GOVERNMENT OF THE DISTRICT OF COLUMBIA
DEPARTMENT OF TRANSPORTATION

MEMORANDUM

SUBJECT: **BZA Case No. 18891** – Florida Ave. and H Street NE

Figure 1. Proposed Site Plan (Source: Applicant)

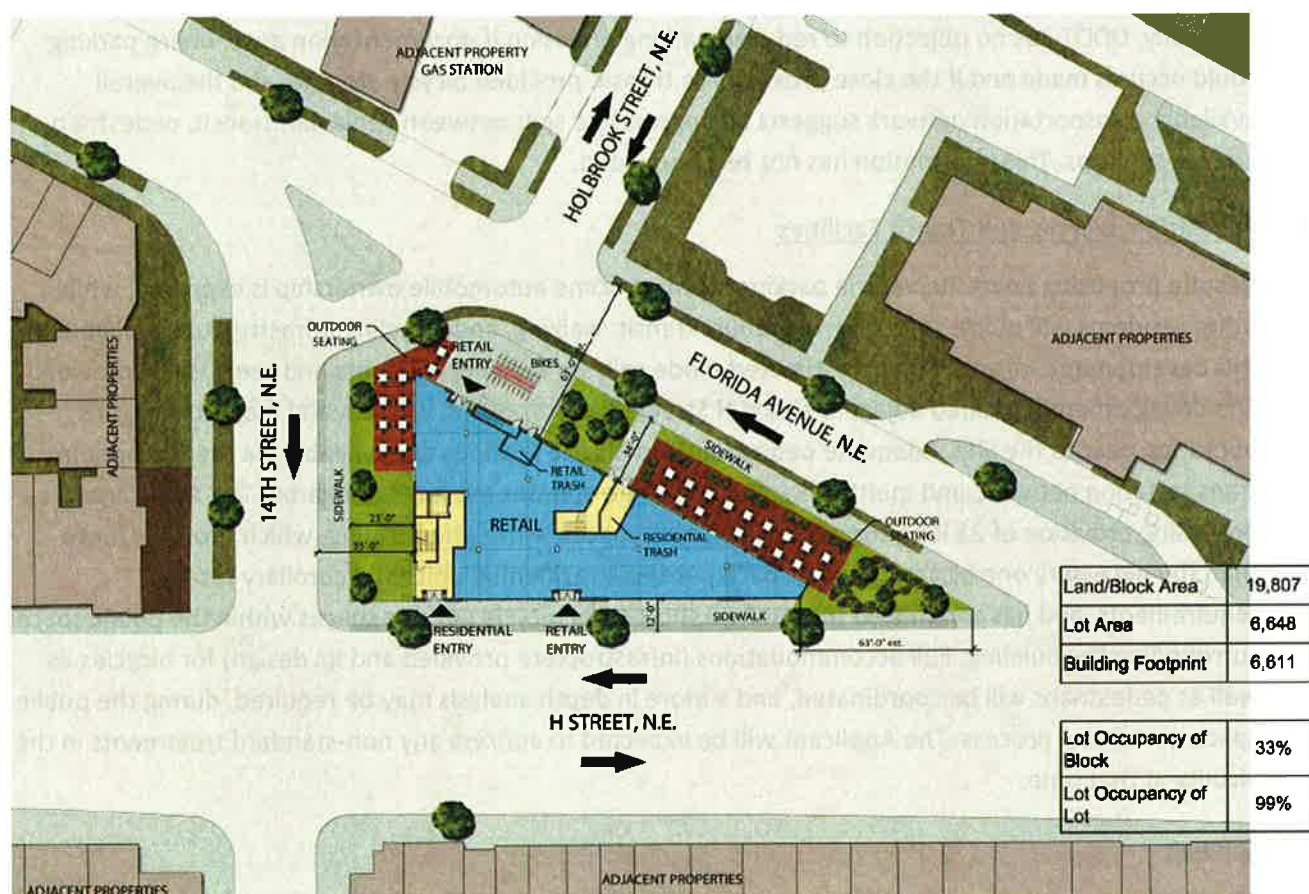
- The public space design should be adjusted to comply with DDOT standards, policy, and practice regarding sidewalk café layout, tree placement, bike parking, sidewalks, utility vault locations, and public parking areas.

- Public space, including café layout, curb and gutter, street trees and landscaping, street lights, sidewalks, bike parking, and other features within the public rights of way, are expected to be designed and built or maintained to DDOT standards;

- All utility vaults are expected to be accommodated on private property;
- Greater specificity as to the design of the long-term bicycle parking;
- A curbside management plan, including the assignment of the loading zone and metered spaces, depending on the proposed loading solution; and

One potential loading solution was submitted by the Applicant, however it features back-in movements from Florida Avenue, a principle arterial, and delivery vehicles parking within public space, and as such would not be permitted by DDOT. Another solution, whereby a new parking lane on Florida Avenue could be created and utilized by the project for loading, as well as adding some vehicular parking spaces, was discussed with the Applicant. But no corollary plans were submitted, nor was there the commitment to this solution.

DDOT expects the Applicant to comply with DDOT's standards for loading, the design of which will be addressed as part of the permitting process for this property. Loading can potentially be accomplished in a safe manner with a better design and planning. Thus, DDOT will need an updated design that accommodates an appropriate loading area that meets current standards.
